January 10, 2017

**BOARD OF COUNTY COMMISSIONERS
ORANGE COUNTY, FLORIDA
ADDENDUM NO. 5 / IFB NO. Y17-722-PH**

**SOUTH WATER RECLAMATION FACILITY SODIUM HYPOCHLORITE STORAGE
AND FEED SYSTEMS IMPROVEMENTS**

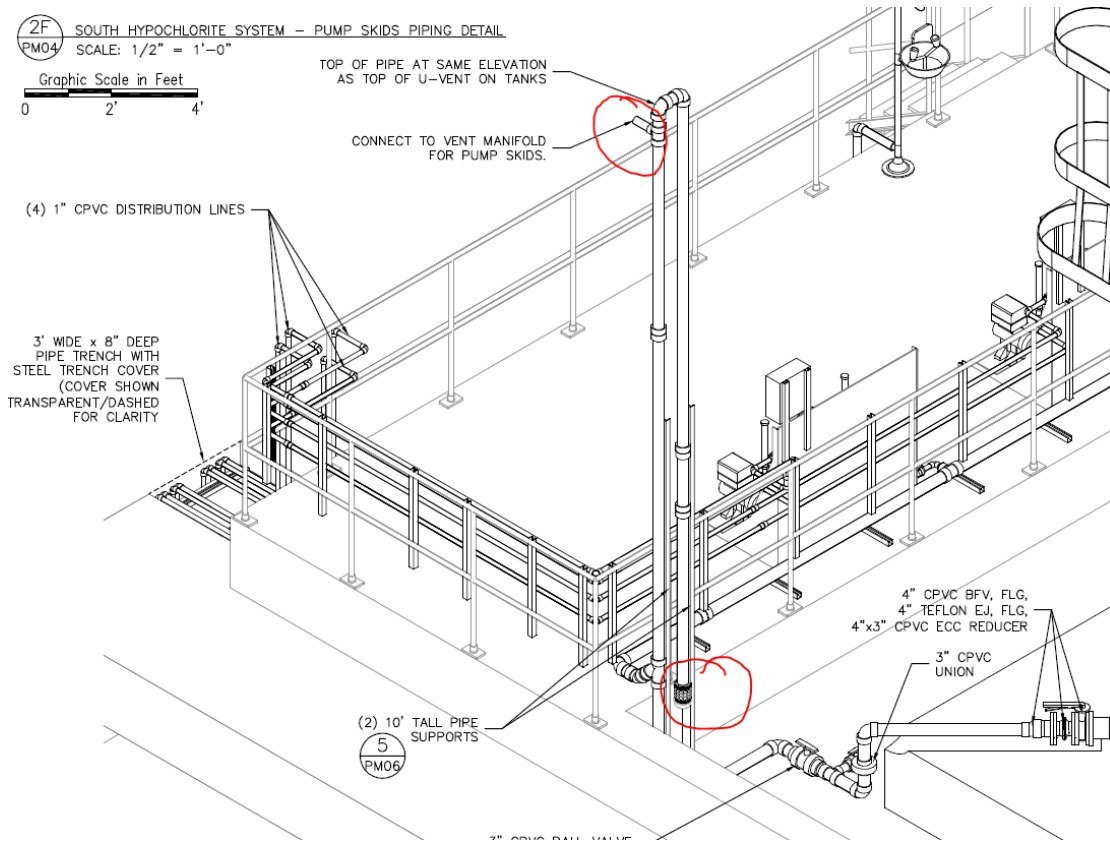
9. Connection to vent manifold (figure below). (No details for connection)

10. What fitting is shown at end of pipe (same figure)? Please clarify.

Response: The connection to the vent manifold shall be a 4"x4"x1 1/4" CPVC Tee, or equivalent 4" CPVC Tee and 4"x1 1/4" CPVC Bushing. The vent manifold serving the pump skids shall be 1 1/4" CPVC suspended from the roof structure.

Response: The end of the pipe shall have a 24-mesh vinyl bug screen secured to the pipe with an All SS 316 hose clamp (TYP).

PROJECT NO.: 110022	
SCALE: NOTED	REVISION: B
DRAWING NO. C03	SHEET NO.: 07 OF 46

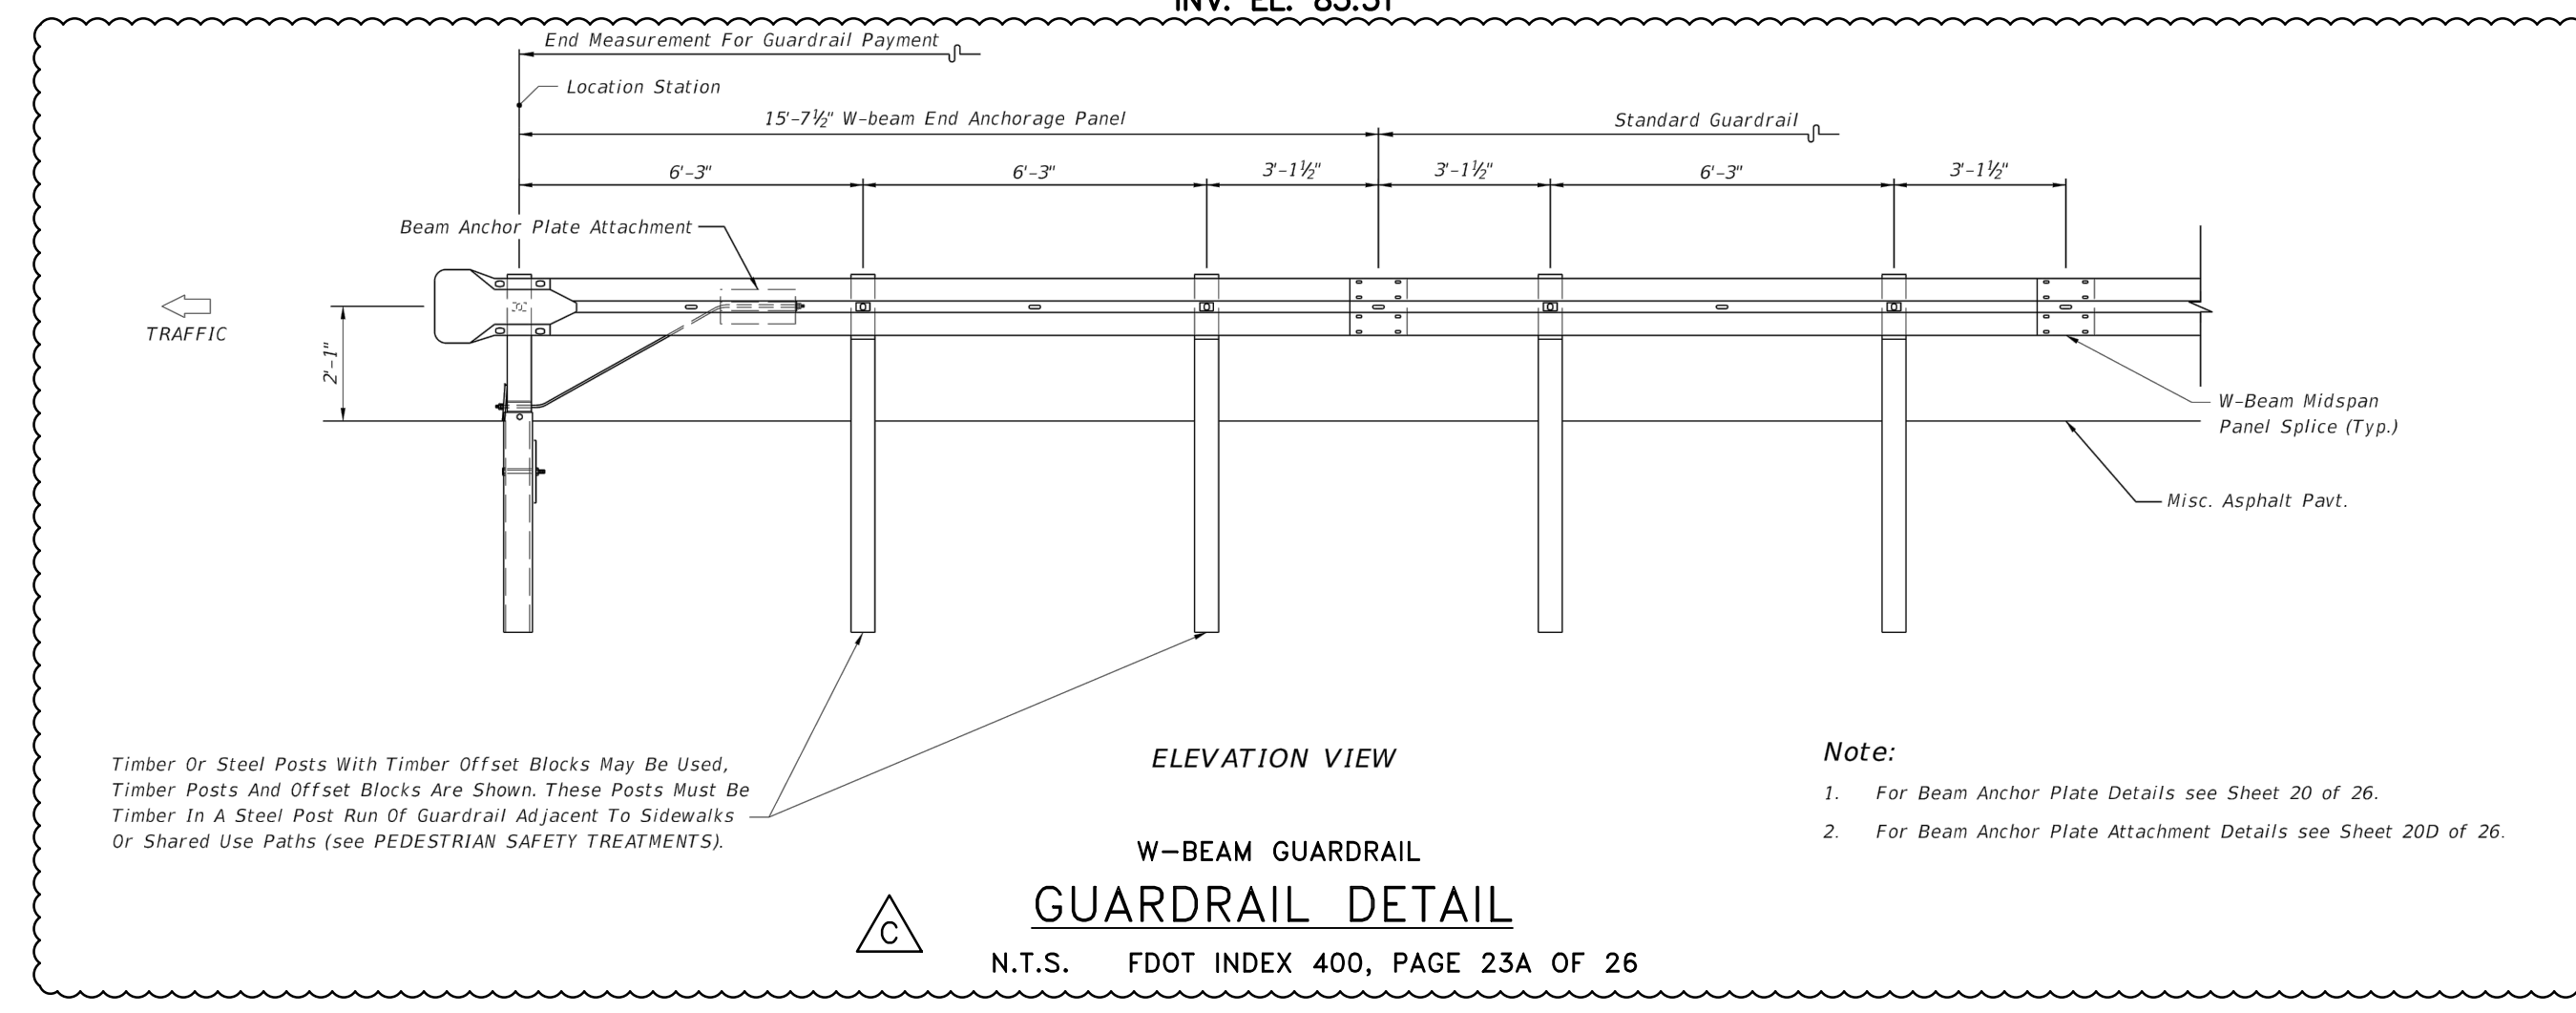
- 4. The guardrails shown on Sheet C03 can't be construction per FDOT**

standards because; On sheet C03 they show the FDOT standard for the parallel end anchors. It shows them at 53' long. So this is 31" tall guardrail. If you construct two of them back to back, that's 106 FT (and in reality, you have to at least have one 12'-6" W beam between them). The run from STA 2+23 -> 2+55 is only 30 feet long. So, you can't even get in one of the end anchors, let alone two back to back. The other run, you can't construct the 53' end anchors on a curve like it shows around STA 0+70. You'd have to take the guardrail all the way around the curve to the top left end of the page to get a full 53' end anchor installed.

Response: The FDOT Guardrail Detail has been revised to depict the "End Anchorage Assembly Type II" rail. The dimensions on the rail allow for the end panels to be installed back to back, with the midspan splice in the middle. The lengths of the guardrails have been revised slightly to account for the dimensions provided on the FDOT detail. The FDOT Index Number and Page from the 2016 FDOT Design Standards has been referenced. See attached revised drawings.(C-3

PROJECT NO.:	110022
SCALE:	NOTED
REVISION:	0
DRAWING NO.:	104
SHEET NO.:	41 OF 46

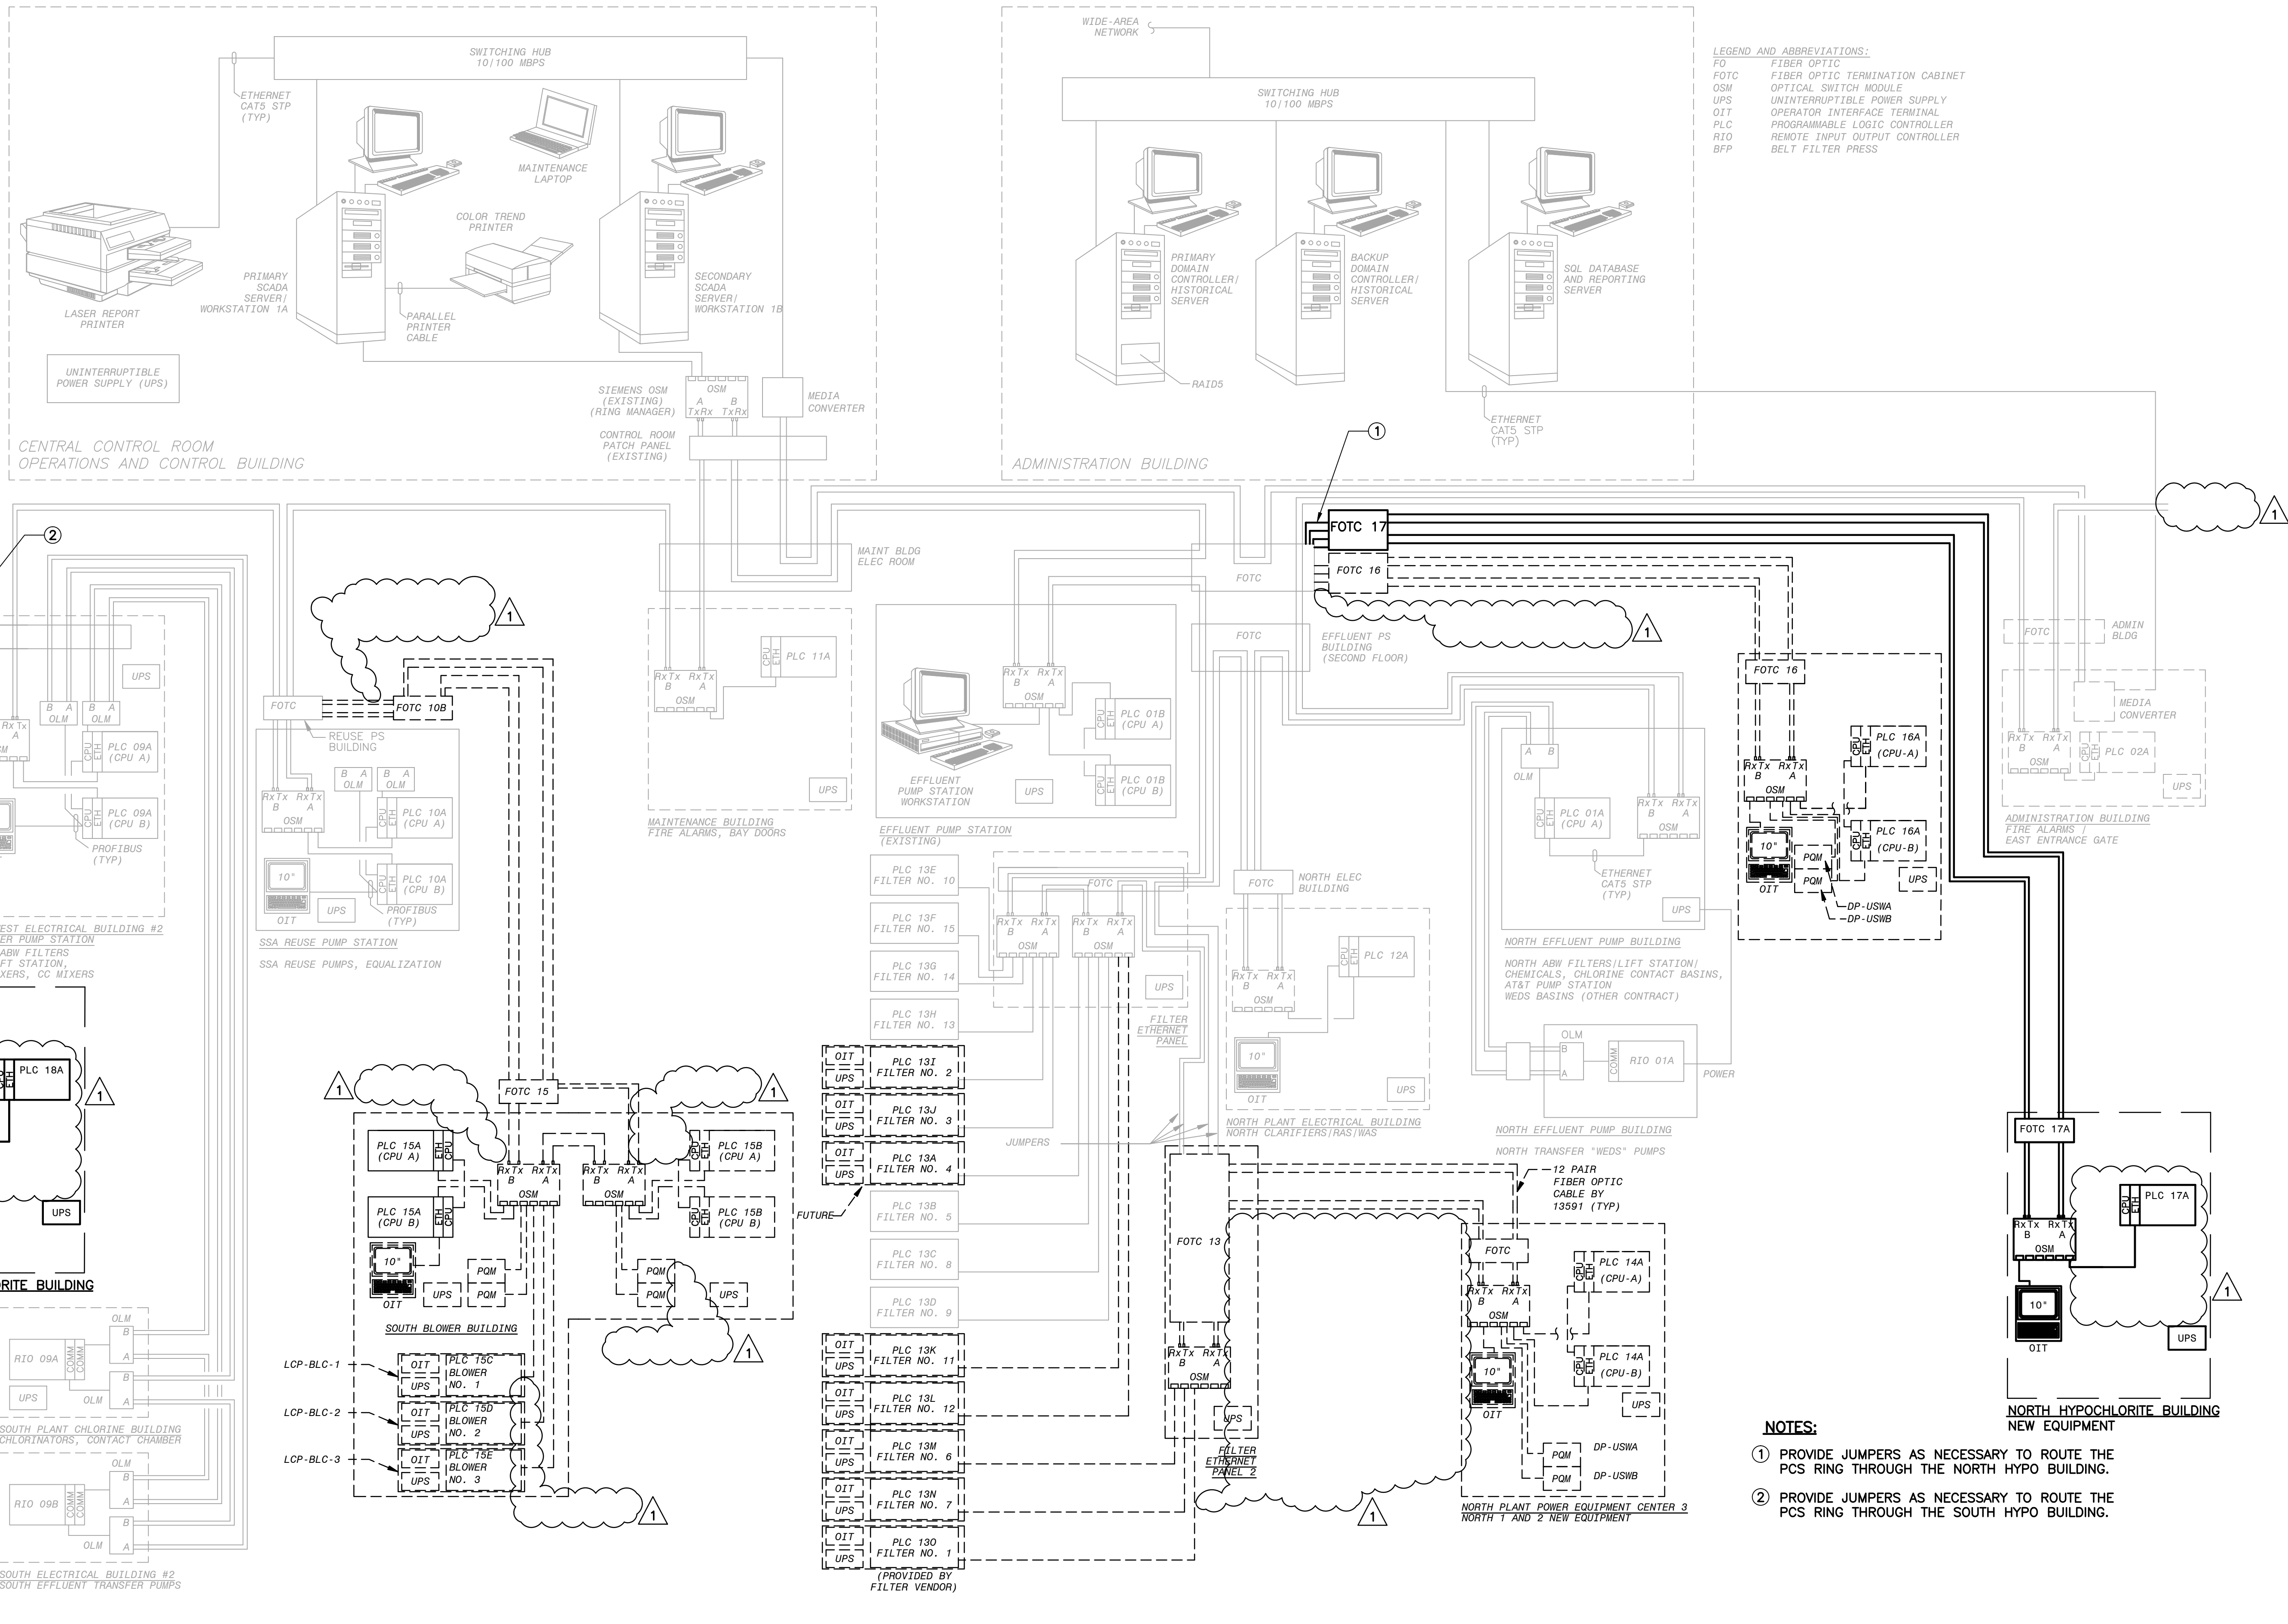
- 2. In Addendum #2 Item 8 "The redundant processor are required" in response to the drawing. Siemens does not offer redundancy in the S7-1500 CPU's Please advise how this will be installed, configured and perform.**

- 7. With respect to the S7 1500 series PLC specified in division 13, the local Siemens representative has informed me that this system is not configurable with a redundant processor. Please confirm the redundancy requirement is not required.**

- 8. Spec section 13300, part 1.01, subsection A, states there is to be two PLCs on this project, North Hypo System PLC-17A and South Hypo System PLC-18A. Please confirm PLC-15A & B plus redundant, Filter Ethernet Panel 2, N Plant PLC-14A & B, and PLC-16A & B (drawing I-4) is for future work and not in contract.**

Response: Contract Drawing I-04 has been revised to eliminate the redundant processor.

Response: Contract Drawing I-04 has been revised to eliminate the redundant processor.

Response: Confirmed that only two PLC (PLC-17A and PLC-18A are required. Other PLC shown on I04 are either existing or future.
